Access Compliance Report

Public Rights-of-Way

(Curb Ramps)

Intersection ID: 10037289	Main Street: SARDIS_RD_NORTH	Cross Street: N/A	Location: SW
ADA ID: 378338ECEBF1	Ramp Type: Perp	Initial Pass/Fail: Fail	Overall Compliance: No
Severity Score: 21.25			
Codes/Mitigation Info/Possible Solution		Field Measurements/Component Compliance

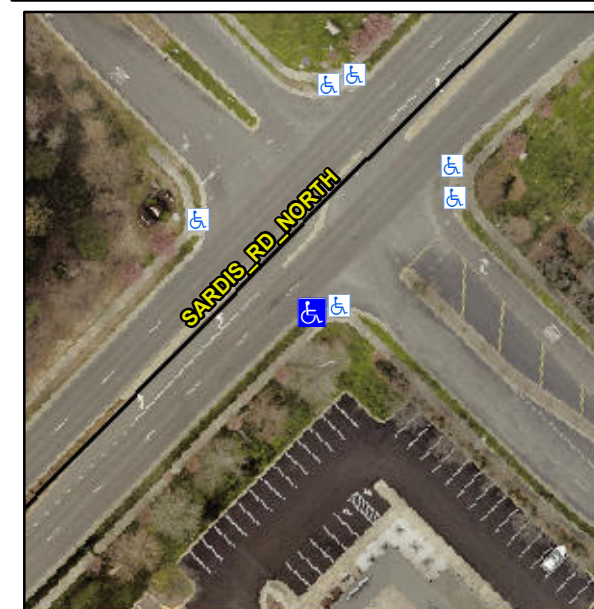
R304.5.1, R304.2.2

Compliance	Description	Data	Compliance	Description	Data
N/A	Ramp Length (in)	77.0	No	Ramp Slope (%)	9.4
No	Ramp Width (in)	40.0	Yes	Ramp XSlope (%)	1.4
N/A	Flare Type LT	N/A	N/A	Flare Type RT	N/A
N/A	Flare Slope LT (%)	N/A	N/A	Flare Slope RT (%)	N/A
N/A	Flare Traversable LT?	N/A	N/A	Flare Traversable RT?	N/A
N/A	Landing Length (in)	N/A	N/A	DWS Provided?	N/A
N/A	Landing Width (in)	N/A	N/A	DWS Contrast?	N/A
N/A	Landing Slope (%)	N/A	N/A	DWS Length (in)	N/A
N/A	Landing X Slope (%)	N/A	N/A	DWS Full Width?	N/A
N/A	Landing Curb? (Y/N)	N/A	N/A	DWS Offset (in)	N/A
N/A	Shared Landing?	N/A			
N/A	Gutter Ponding?	N/A	N/A	Gutter Slope (%)	N/A
N/A	Gutter Lip Ht (in)	N/A	N/A	Gutter X Slope (%)	N/A
N/A	Painted X Walk1?	No	N/A	Painted X Walk2?	N/A
	X Walk 1 Direction	To NW		X Walk 2 Direction	N/A
N/A	X Walk 1 Width (in)	N/A	N/A	X Walk 2 Width (in)	N/A
	X Walk 1 Slope (%)	3.5		X Walk 2 Slope (%)	N/A
	X Walk 1 X Slope (%)	0.4		X Walk 2 X Slope (%)	N/A

Remove & Replace Entire Ramp.
